May 2, 1994

The letter in reference is from David A. Lochbaum and Donald C. Prevatte, and expresses their concerns regarding a safety hazard involving the design of the Susquehanna Steam Electric Station, and thirty five other similarly designed plants (Atch. 1). Alabama has three of these units at TVA's Browns Ferry Nuclear Plant near Athens, Alabama.

## Substantial Nuclear Safety Hazard Loss of Spent Fuel Pool Cooling

Figure 1

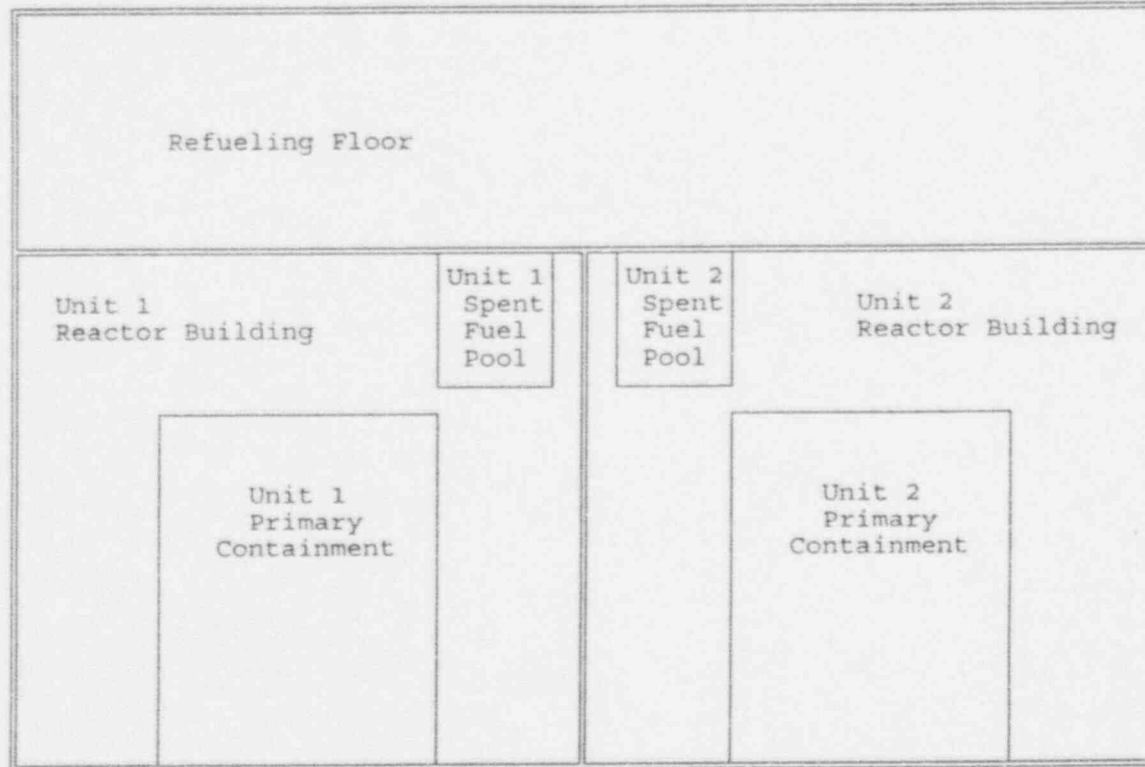
Each unit in the Susquehanna plant contains a General Electric Boiling Water Reactor. Nuclear fuel is contained in reactor vessels which are housed within primary containments constructed of steel and reinforced concrete. Secondary containments (also called reactor buildings) surround these primary containments, as well as the spent fuel pools which are located on a refueling floor common to both units (see Figure 1 for a simplified arrangement drawing). Most of the plant's emergency systems as well as the systems for cooling the spent fuel pools are also located inside the secondary containments.

The same accident signals which automatically start the emergency systems also turn off the electrical power to the Fuel Pool Cooling System. Thus, the accident results in the loss of cooling for the spent fuel pool. In order to restart the Fuel Pool Cooling System, operators must enter the reactor building. However, as described above, radiation levels would prohibit safe entry. Therefore, the system cannot be restarted.

hours for the current loading of the Unit 1 fuel pool. If the fuel pool boils, its water will rapidly evaporate, and replacement water must be provided. If it is not, within a short time the extremely radioactive spent fuel bundles, which are normally covered with water, will be uncovered. However, the valves which must be opened to provide this replacement water are also within the inaccessible reactor building. Therefore, the replacement water cannot be provided.
